UNITED STATES
 NUCLEAR REGULATORY COMMISSION
 REGION V
 1450 MARIA LANE, SUITE 210
 KALNUT CREEK, CALIFORNIA 94596

SUBJECT: ALLEGATION TRACKING SYSTEM NO. RV-83-A-0055

This refers to your telephone call on November 8, 1983, in which you expressed concerns related to PG&Es alleged negligence in providing an adequate response to flooding, identified and reported by you and other guards, in the pipe tunnel at Diablo Canyon Unit 1.

DETAIL (S221)

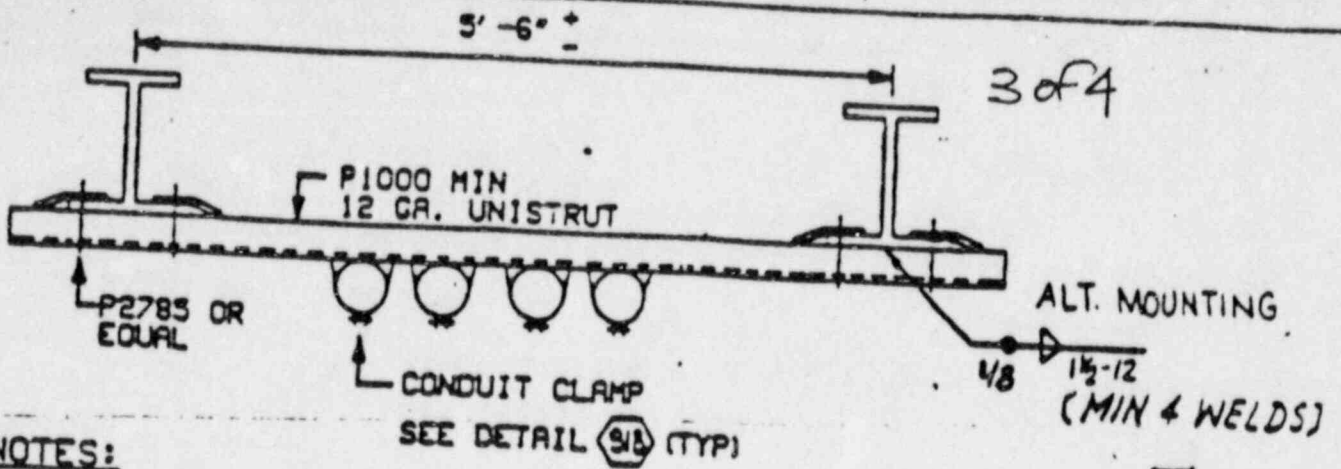
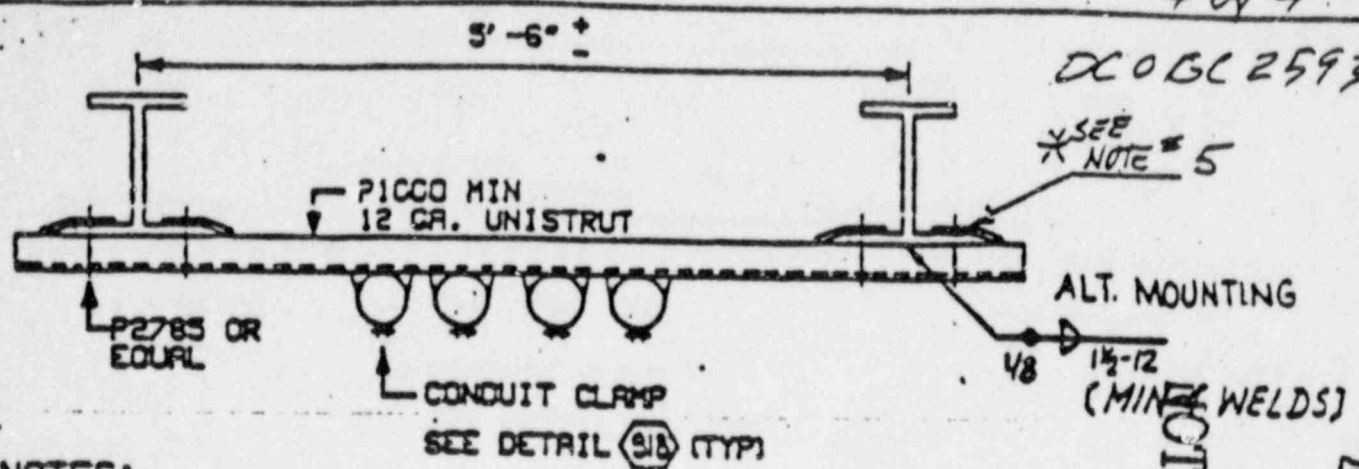
1. Current revision of DCO-GE-2593 specifies that Note 5 shall be used if beam clamps are utilized for support, Detail S221 REV. 24 (torque and tack weld). Discrepancy exists in that there is no prequalified WPS procedure to use tack welds, at this time.
2. The current S221 support detail has deleted Note 5 without any revision change or revision date prior to the inspection of C.O. #4376.

NOTE: This is a general problem for Detail S221.
